Subject: Amended MHI's Response to US-APWR DCD RAI No.584-4468 Revision 0 (SRP 09.02.02)

Amended Responses to Request for Additional Information
No. 584-4468, Revision 0

RAI NO.: NO.584-4468 REVISION 0
SRP SECTION: 09.02.02 – Reactor Auxiliary Cooling Water Systems
APPLICATION SECTION: DCD Tier 2 Section 9.2.7
DATE OF RAI ISSUE: 05/10/2010

Figure 9.2.7-1 Essential Chilled Water System Flow Diagram (Sheet 1 of 4)

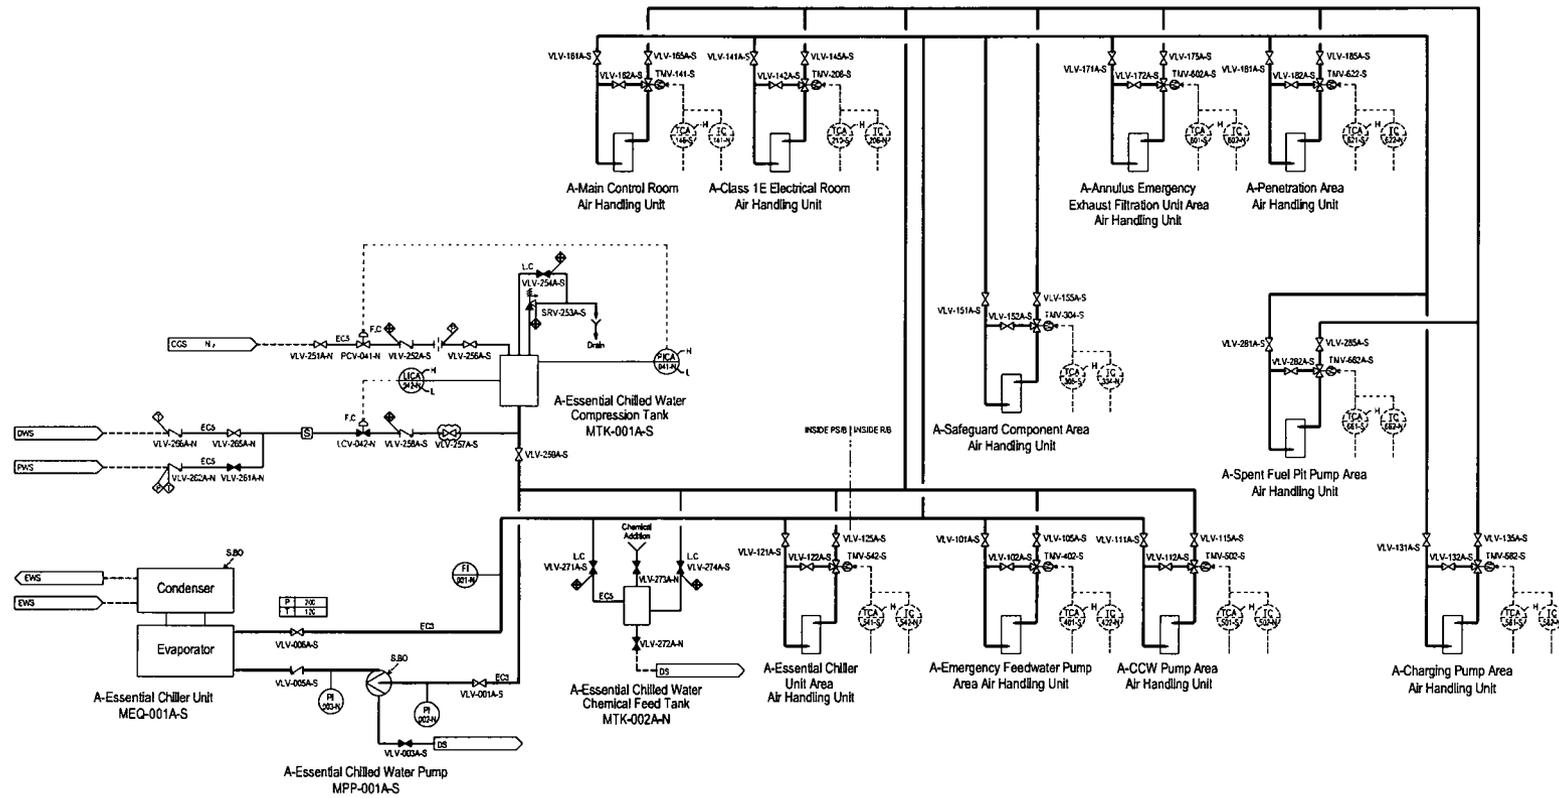
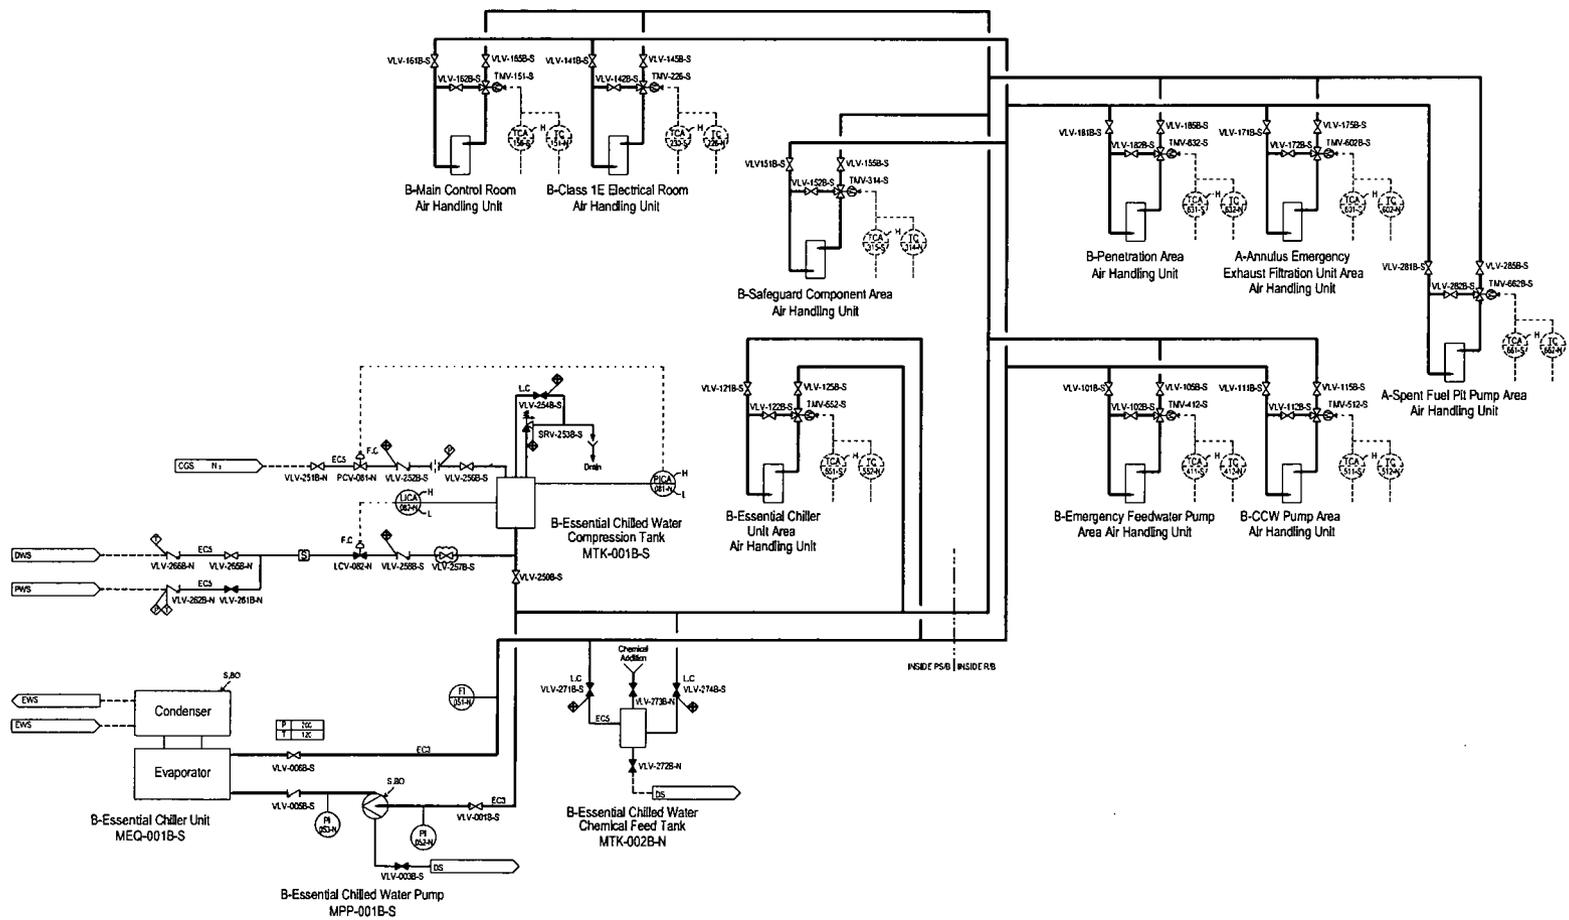
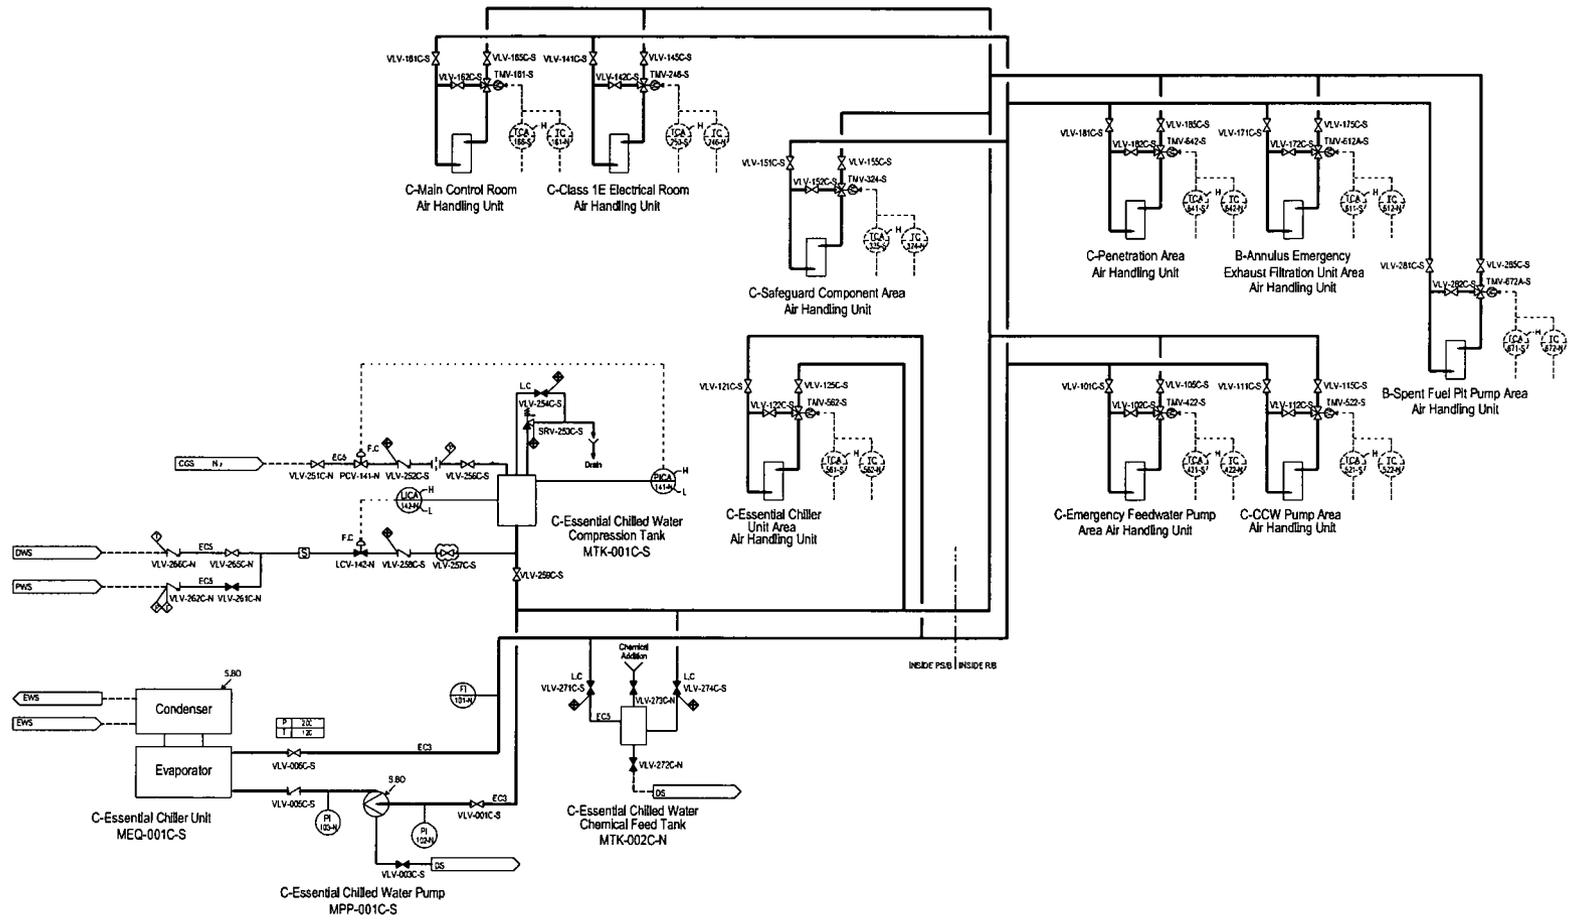
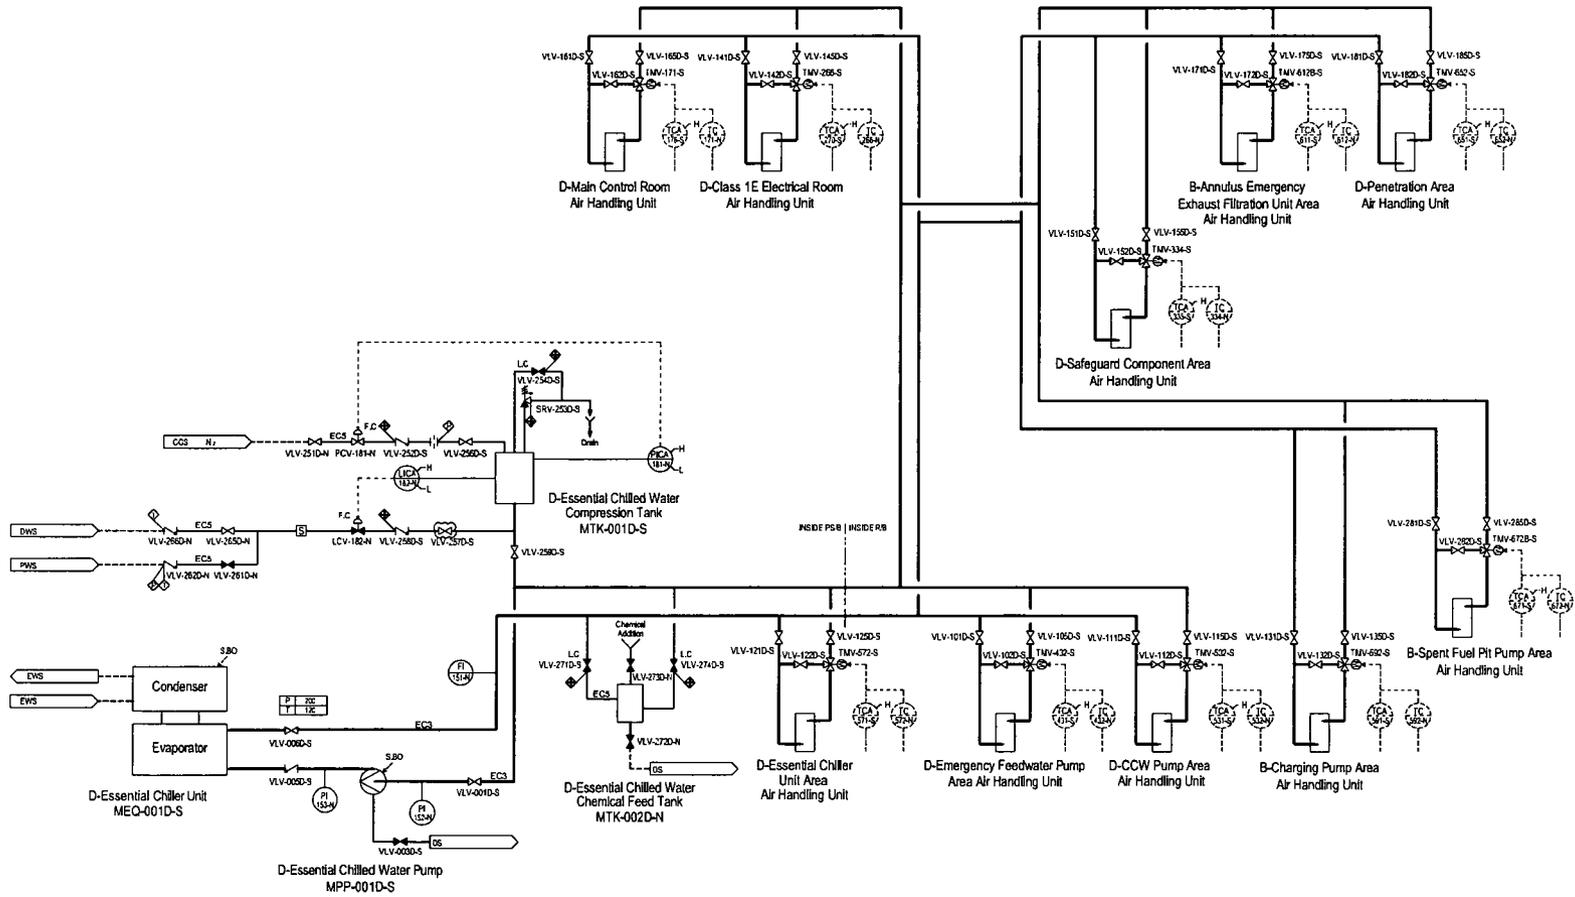
1. The staff asked the applicant to revise the DCD to address Tier 2, DCD Figure 9.2.7-1 not showing where indications are displayed (e.g., local, remote panel, control room), and what instruments provide input to a process computer and/or have alarm and automatic actuation functions. This item was not addressed anywhere in the applicant's RAI response. Therefore, the applicant is asked to address the original staff request to show on Figure 9.2.7-1 where indications are displayed and what instruments provide input to a process computer and/or have alarm and automatic actuation functions. Or, as indicated in RG 1.206 (C.I.9.2.1.5), describe the system alarms, instrumentation, and controls. Include a description of the adequacy of instrumentation to support required testing, as well as the adequacy of alarms to notify operators of degraded conditions.

The staff asked the applicant to revise the DCD to address Tier 2, DCD Figure 9.2.7-1 not showing where indications are displayed (e.g., local, remote panel, control room), and what instruments provide input to a process computer and/or have alarm and automatic actuation functions. This item was not addressed anywhere in the applicant's RAI response. Therefore, the applicant is asked to address the original staff request to show on Figure 9.2.7-1 where indications are displayed and what instruments provide input to a process computer and/or have alarm and automatic actuation functions. Or, as indicated in RG 1.206 (C.I.9.2.1.5), describe the system alarms, instrumentation, and controls. Include a description of the adequacy of instrumentation to support required testing, as well as the adequacy of alarms to notify operators of degraded conditions.

For question 5 [from RAI 343-2208, Question 09.02.02-13 response], explain why all instrumentation described in Section 9.2.7.5 are not found on Figure 9.2.7-1 and 9.2.7-2. In addition, indicate whether expansion tank level alarm should be included in Section 9.2.7.5.

DCD, Revision 2, incorporated changes to Figure 9.2.7-1 to include additional details related to instrumentation and controls for the essential chilled water system (ECWS), such as compression tank level indication, control and alarm; air handling unit temperature control; and chiller and chilled water pump automatic start signals. The instrumentation and control level of detail shown on Figure 9.2.7-1 is consistent with other system P&IDs within DCD Chapter 9. Additional description of ECWS instrumentation and control is provided in DCD Section 9.2.7.5.1. The automatic start of standby ECWS chillers and pumps upon receipt of an ECCS actuation signal is described in DCD Section 9.2.7.2.1.

DC applicant will revise Figure 9.2.7-1 and 9.2.7-2 to indicate that the ECWS compression tank relief valve discharge is routed to a local floor drain. .

The automatic initiation signals for the ECWS chiller units and chiller pumps are indicated on DCD Figure 9.2.7-1 as "S, BO" with an indicator pointing to the chiller unit and the chiller pump. As indicated on DCD Figure 1.7-3, Legend for Piping and Instrumentation Diagrams of Primary Systems, "S" indicates a Safety Injection Signal (i.e., the ECWS automatic start on an ECCS initiation signal) and "BO" indicates a Blackout Sequence Signal (i.e., the ECWS automatic start on a LOOP initiation signal).

- High and low pressure indication with an alarm of the compression tanks – *shown on Figure 9.2.7-1 {ex.: PICA-041-N}*
- Chilled water flow failure of the chilled water pumps – *shown on Figure 9.2.7-1 {ex.: FI-001-N}*

- Pressure indicator at the chilled water pumps suction and discharge nozzles – *shown on Figure 9.2.7-1 {ex.: PI-002-N and PI-003-N}*
- Chiller oil pressure indicators, suction pressure indicator and discharge pressure indicators – *supplied as part of the ECWS chiller package and not shown on Figure 9.2.7-1*

DC applicant will revise Tier 2, DCD Revision 3, Section 9.2.7.5.1 to include ECWS compression tank level indication and alarm in the list of MCR instrumentation and to provide additional description of the function of the MCR instrumentation. The compression tank level indication symbols in Figure 9.2.7-1 and 9.2.7-2 will be revised to be consistent with following change:

Figure 9.2.7-2 Non-Essential Chilled Water System Flow Diagram (1 of 3)

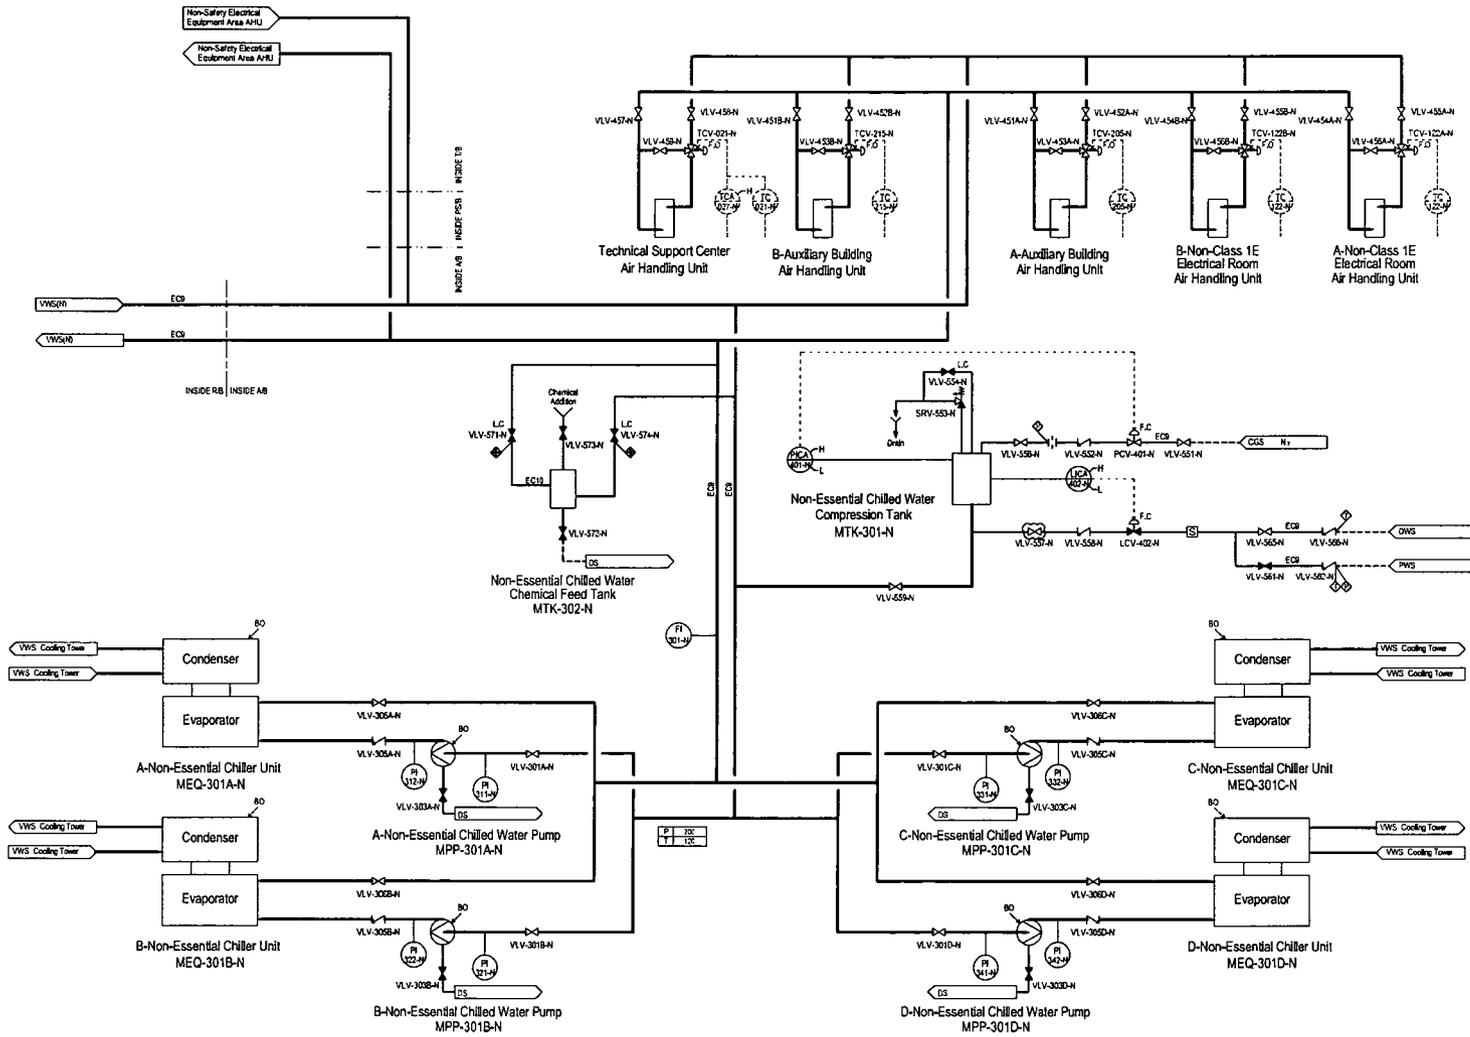
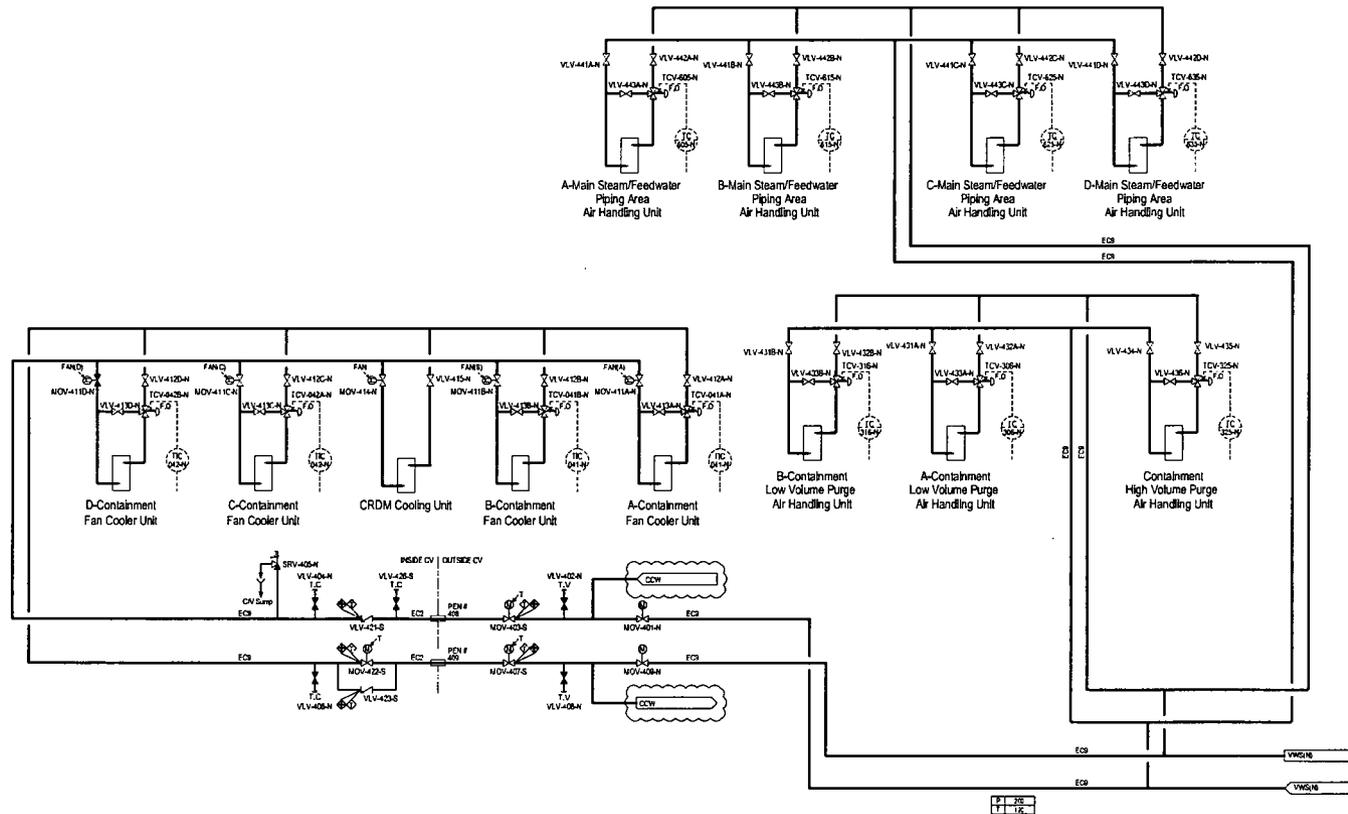
4. Tier 2 Table 3.2-2 (page 55 of 57) references "Valves VWS-MOV-425, -426" as Seismic Category I. However, Valve "-426" is not shown on non-ECWS Figure 9.2.7-2.

Tier 2 Table 3.2-2 (page 55 of 57) references "Valves VWS-MOV-425, -426" as Seismic Category I. However, Valve "-426" is not shown on non-ECWS Figure 9.2.7-2.

VWS-MOV-426 was erroneously listed in DCD Table 3.2-2. In addition, as described in the response to DCD RAI 697-5502, Question 09.02.02-80, the valve numbers VWS-MOV-424 and 425 shown in DCD Revision 3 will be changed to NCS-MOV-241 and 242. Therefore, Table 3.2-2 will be revised to remove the valves VWS-MOV-424 and 425. Figure 9.2.7-2 will be revised to incorporate these changes.

DCD Figure 9.2.7-2 will be revised to delete the CCW supply and return line isolation valves, VWS-MOV-424, 425, since the valves are changed to NCS-MOV-241 and 242 as described in the response to DCD RAI 697-5502, Question 09.02.02-80.
